COASTER

OUTLINE OF NEW FEATURES

The following changes are made for the new Coaster.

3. Clutch

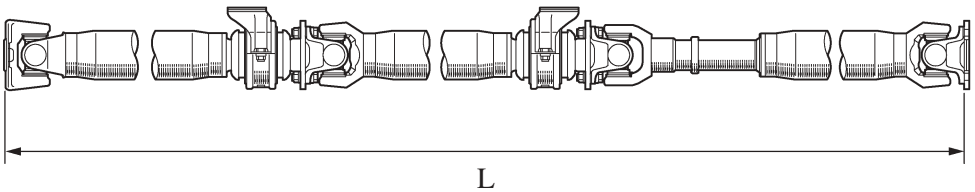
A dry type single plate clutch that is operated by hydraulic pressure is used for the N04C-TQ engine models.
